भारत सरकार-रेल मंत्रालय  
अनुसंधान अभिकल्प और मानक संगठन  
लखनऊ- 226011  
Government of India - Ministry of Railways  
**Research, Designs & Standards  
Organization, LUCKNOW - 226011**

**Modification Sheet No: RDSO/2012/EL/MS/0408 ( Rev'0' )**

Modification of terminal connection of heater cum blower assembly.

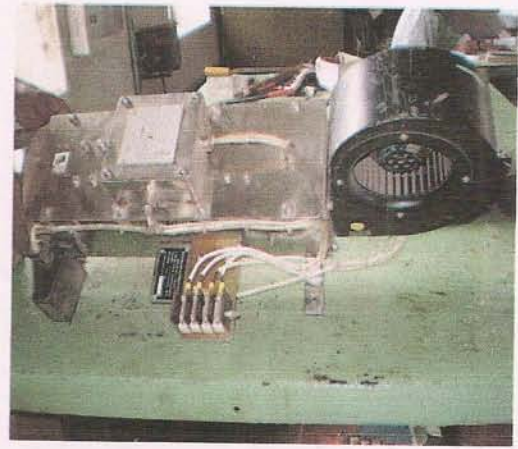
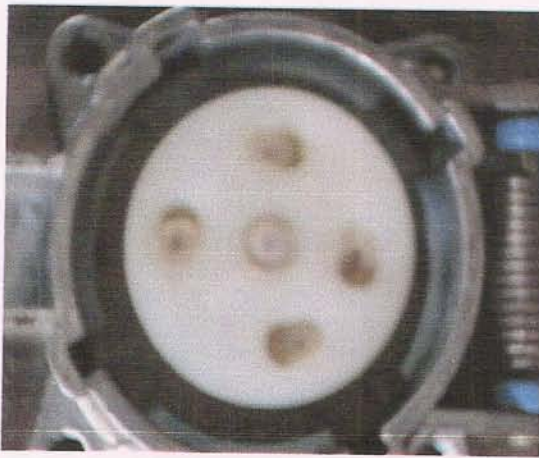
The blower cum heater assembly same as in three phase locos is now being provided by CLW in conventional locos. The item is being procured as per CLW specification no CLW.ES.03.0109 for both type of locos. SI unit tripping have been observed due to failure of this item. In existing plug & socket system, 440V AC supply for 2KW heater & 230V AC for 115W blower motor are available in same socket & very adjacent to each other. The terminals gets over heated & melted due to loose & improper connection caused by vibration of loco. Due to overheating, the Bakelite also melts causing short circuit of phase to phase & phase to neutral terminal thus leading to tripping of Static Inverter.

AJJ shed (SR) has modified the existing terminal connections by SB type terminals connections in few locomotives and performance has been found satisfactory. The photographs of existing and modified arrangement are shown below.

Existing arrangement-Plug & socket connection

Modified arrangement-SB terminal connection

Remove Existing plug & socket and replace it by 6 SB terminal(2 spare terminals) as shown in above photographs.
